**TOWN OF NEWBURGH
PLANNING BOARD
TECHNICAL REVIEW COMMENTS**

PROJECT: PET HOTEL AND DAYCARE (MIDDLEHOPE VET)
PROJECT NO.: 2012-19
PROJECT LOCATION: SECTION 9, BLOCK 3, LOT 22.1 & 23 & 22.2
REVIEW DATE: 31 MARCH 2017
MEETING DATE: 6 APRIL 2017
PROJECT REPRESENTATIVE: T.M. DEPUY ENGINEERING & LAND SURVEYING, P.C.

Re: Proposed Pet Hotel &
Day Care Facility
Section 9, Block 3,
Lots 22.2, 23 & 22.1 (P/O)
Town of Newburgh Job #2012-19

I PARKING AREA LIGHTING
SCALE: AS NOTED

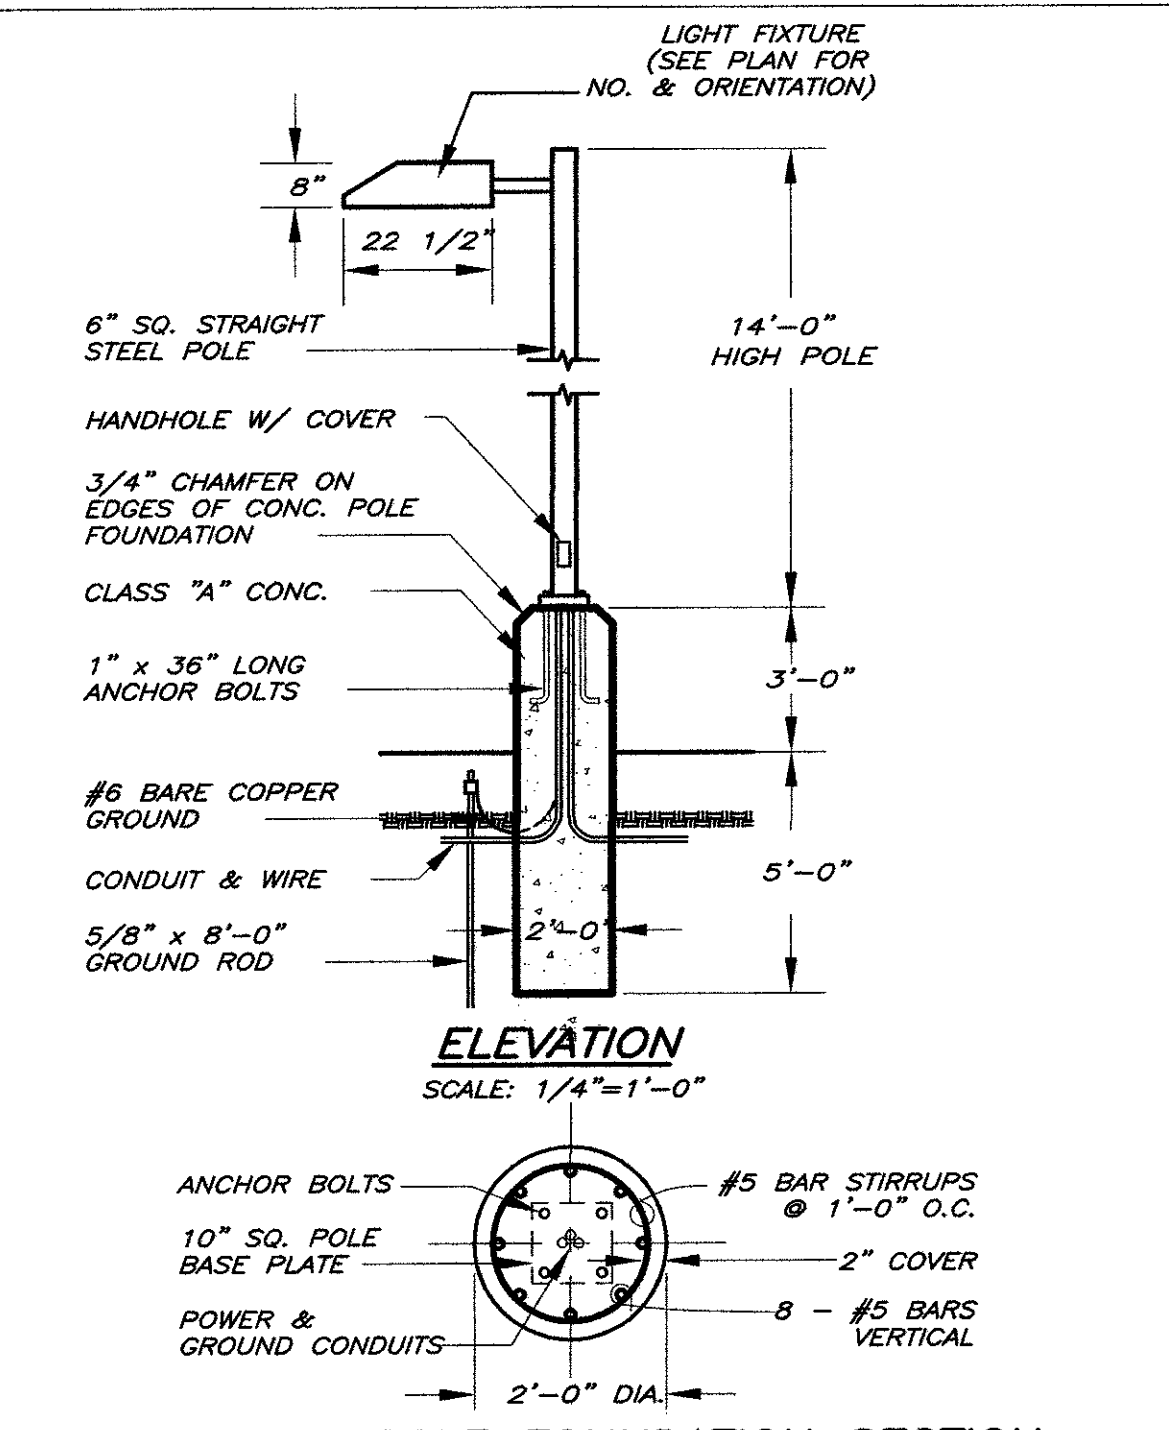
10. Legal documents concerning the shared septic facility are being finalized.
11. So noted.
12. Two new area light poles have been indicated on the drawings; see SP2 and a detail provided on SP6.

LANDSCAPE PLAN

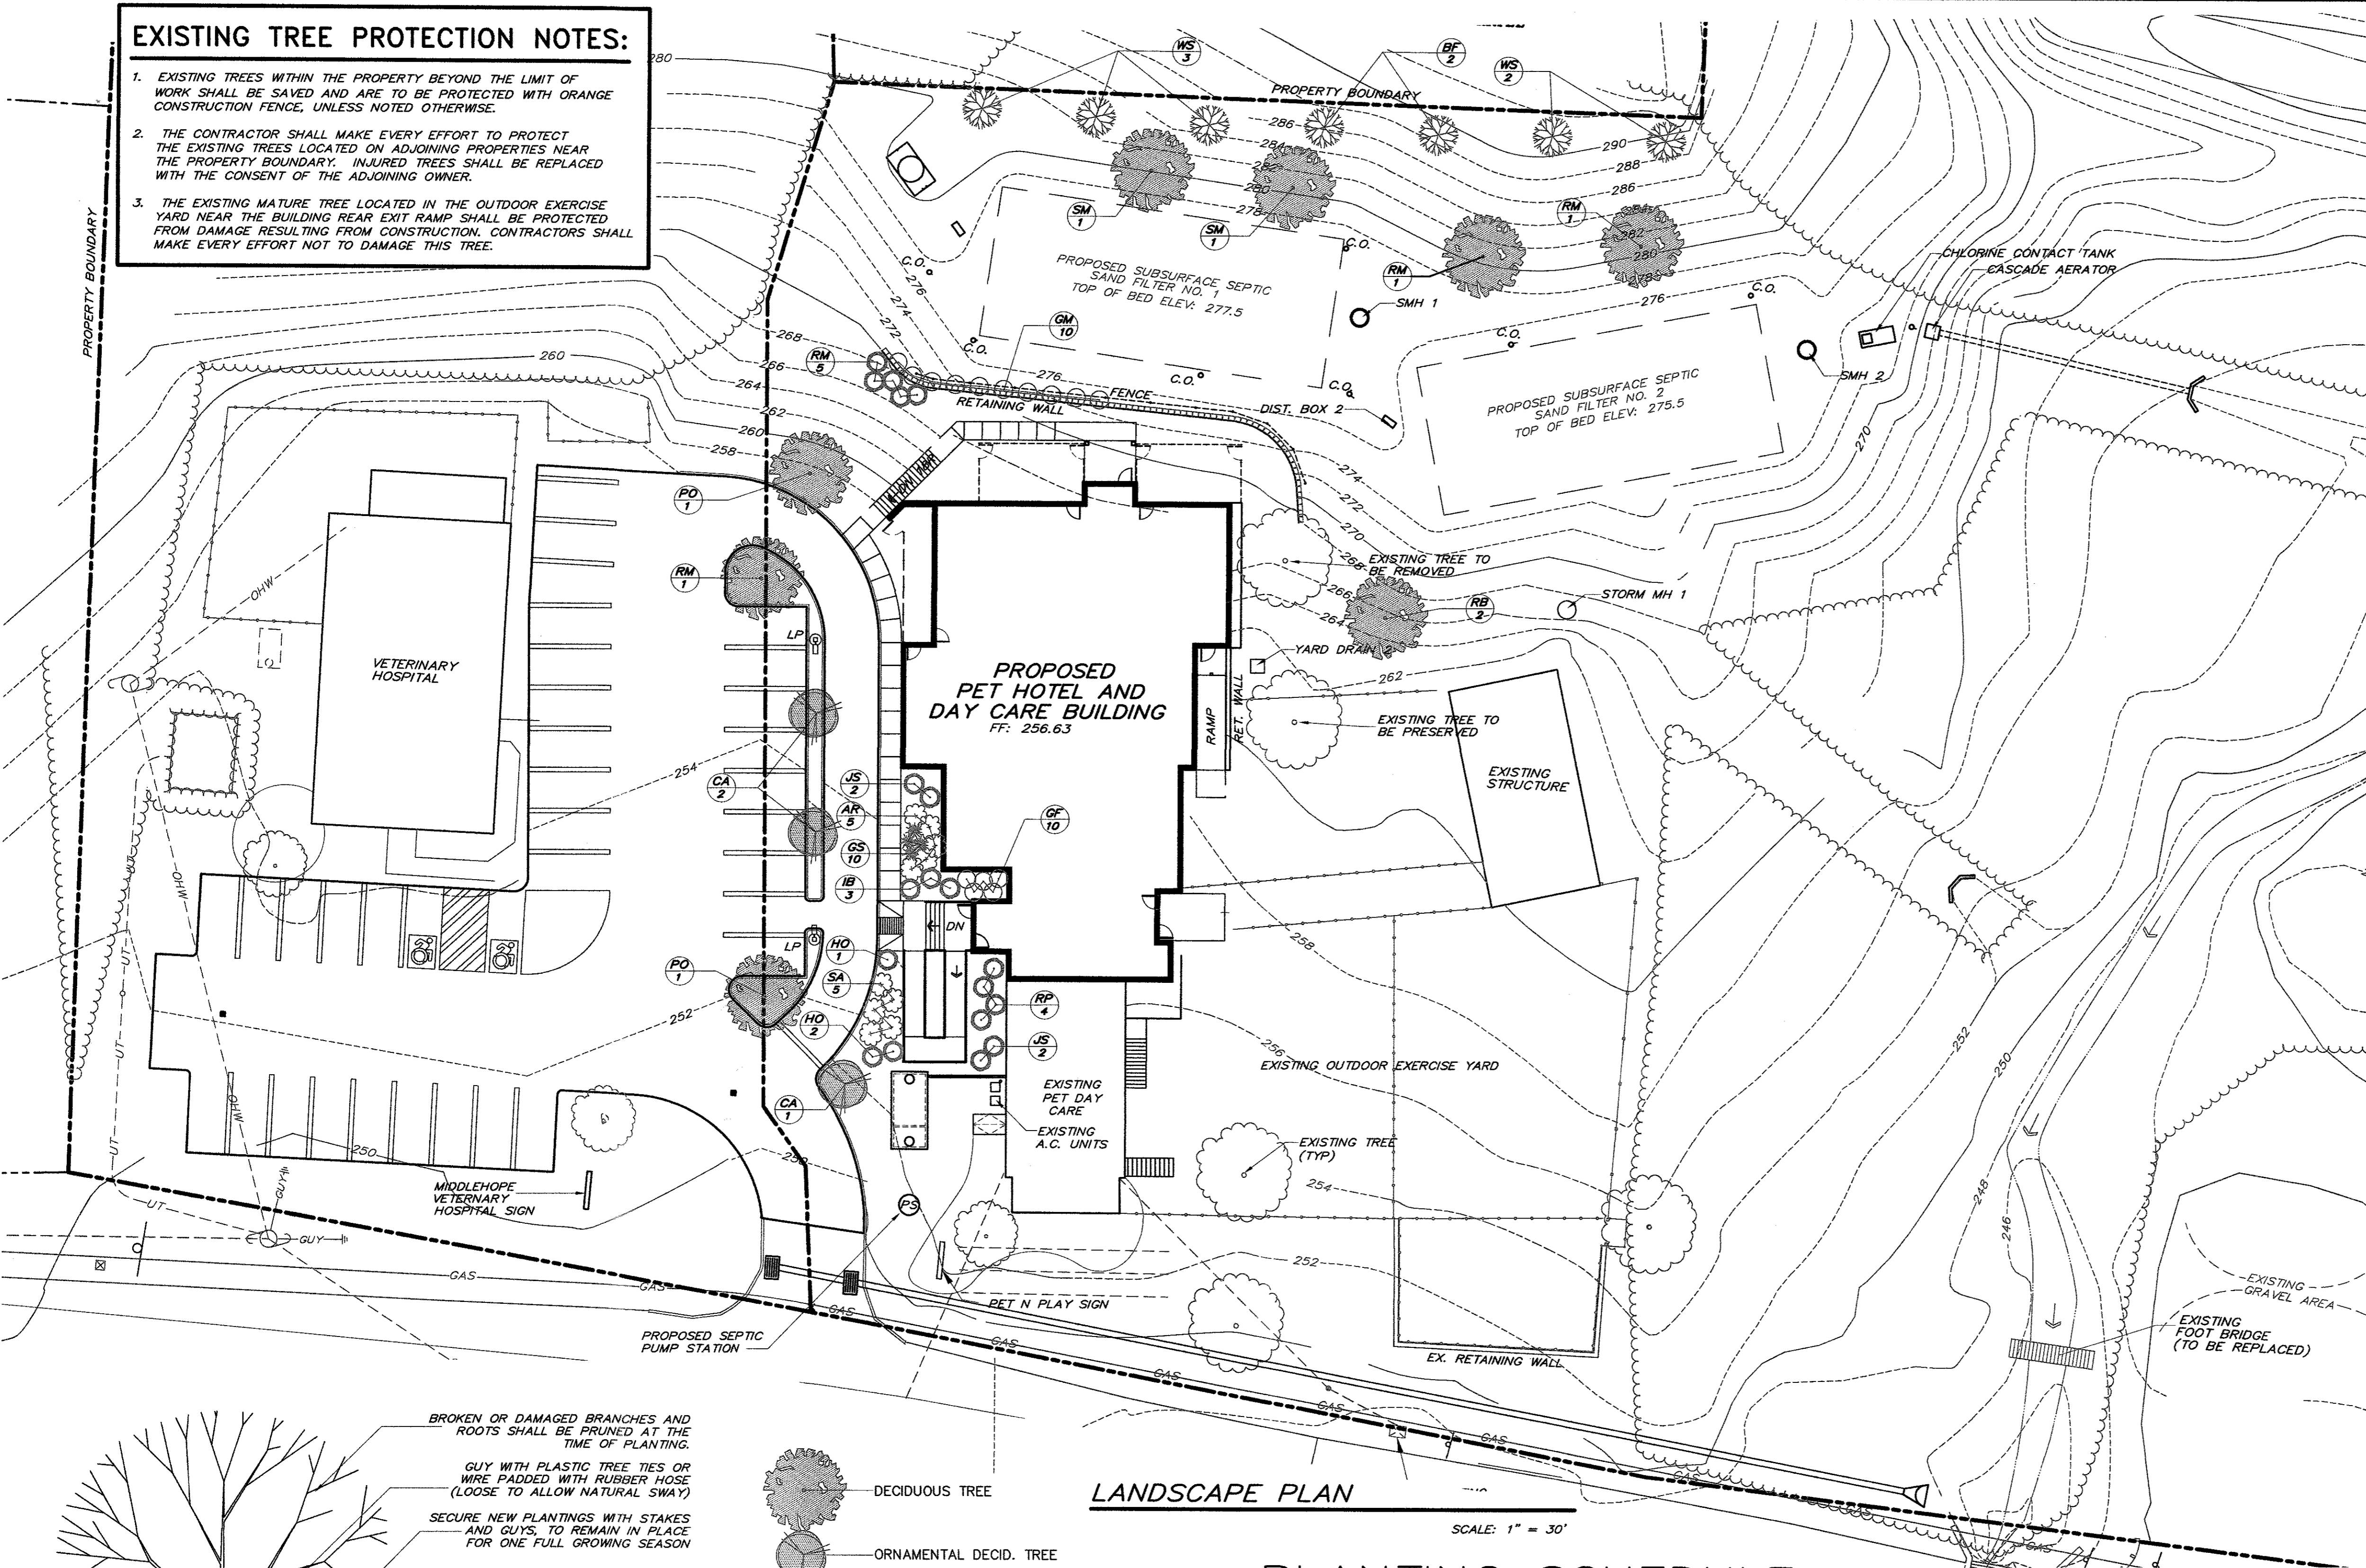
5. A Landscape Plan has been submitted for the Planning Board use. Planning Board should evaluate the Landscape Plan with regard to acceptability to the Board.

- 15. So noted.
- 16. The grading occurring on 9-3-22.1 is related to the development of the expanded pet hotel and day care facility. The ownership of the two lots are the same; therefore, we do not believe a cross grading easement is required.
- 17. So noted.
- 18. A soil erosion and sedimentation plan has been provided. SWPPP1, SWPPP2 & SWPPP3.
- 19. A detail of the retaining wall has been added to the plans; see SP7.
- 20. The details for the proposed sidewalk and stairways have been added to the plans, see SP6.
- 21. A landscape plan has been provided, see SP8.
